**Re:** Bus Connects Templeogue/Rathfarnham to City Centre Core Bus Corridor Scheme  
Templeogue/Rathfarnham to City Centre

**Submission to An Bord Pleanála in respect of the BusConnects -  
Templeogue/Rathfarnham to City Centre Core Bus Corridor Scheme (ABP – 316272-  
23)**

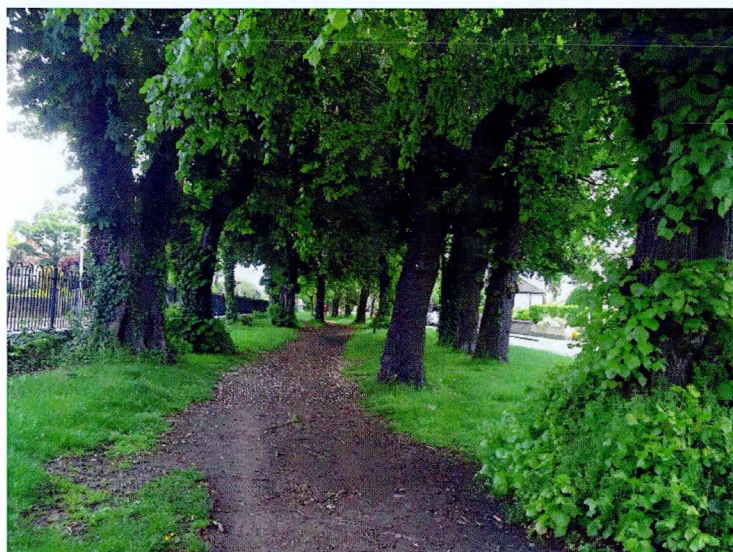
Much of what makes Dublin unique is its architectural heritage and other features of its built environment. Running along the Templeogue Road side of Bushy Park is a stone wall built in 1800. Sheet 35 of Vol. 1, General Arrangement Drawings, which shows this section of the park, includes a note stating that the area includes a number of ‘high value heritage lighting columns’ and ‘lengths of historic granite kerbs’. It states that the latter will be retained ‘where practicable if kerbs are not being adjusted’ and that ‘if kerbs are to be realigned [they will] be

reused where practicable.’ The repeated use of ‘if practicable’ is highly worrying and again seems intended to give the Scheme the leeway to do as it pleases. However, it is especially worrying that it makes no mention of the stone wall, merely the ‘high value’ lighting fixtures and the granite kerbs, seemingly making it clear that the wall (and the trees next to it) are considered to be of no consequence and therefore may well be destroyed. It is unacceptable that the historic structures of the city be treated so apparently flippantly. The wall must be retained.

the stone wall with plaque along Rathdown Drive

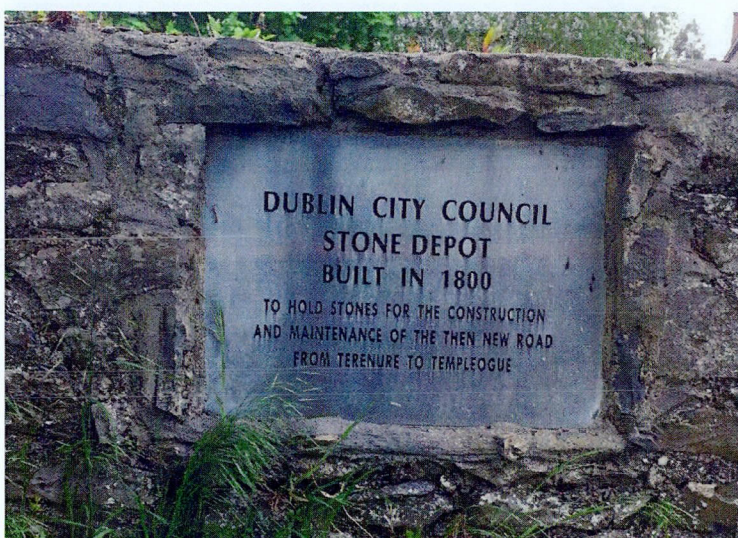
Similarly, there is a section of stone wall along the green space of Rathdown Drive and set within it is a plaque (approximately opposite house no. 41; see sheet 35 of Vol. 1, General Arrangement Drawings), which states ‘Dublin City Council Stone Depot, built in 1800 to hold stones for the construction and maintenance of the then new road from Terenure to Templeogue’ (a photo of which is included below). This, too, is an important historical structure, though admittedly a modest one, and must be retained, though, again, there is no specific mention of it at all in the Scheme. (Again, this is probably because none of the individuals drawing up the Scheme ever bothered to visit the site and so have no knowledge whatsoever of it.)
